#### SUNDRY NOTICES AND REPORTS ON WELLS

# P&A Surface Reclamation Plan Little Angel #1

Well: Little Angel #1

### CONDITIONS OF APPROVAL

## Planned Wellbore Schematic

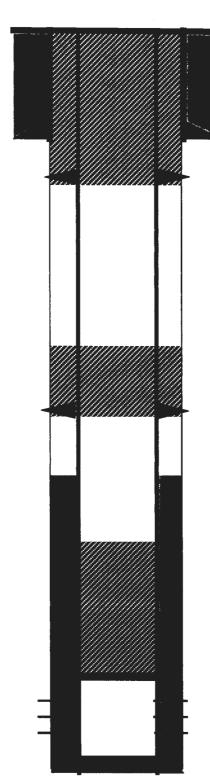
- 1. Plugging operations authorized are subject to the attached "General Requirements for Permanent Abandonment of Wells on Federal and Indian Lease."
- 2. Farmington Office is to be notified at least 24 hours before the plugging operations commence (505) 564-7750.
- 3. The following modifications to your plugging program are to be made:
  - a) Set plug #1 (3686 3232) ft. to cover the Fruitland, Kirtland, and Ojo Alamo tops. BLM picks top of Fruitland at 3539 ft. BLM picks top of Kirtland at 3492 ft. BLM picks top of Ojo Alamo at 3282 ft.
  - b) Set plug #2 (2097 1997) ft. inside/outside to cover the Nacimiento top. BLM picks top of Nacimiento at 2047 ft.

Operator will run CBL to verify cement top. Submit the electronic copy of the log for verification to the following addresses: jwsavage@blm.gov Brandon.Powell@state.nm.us

You are also required to place cement excesses per 4.2 and 4.4 of the attached General Requirements.
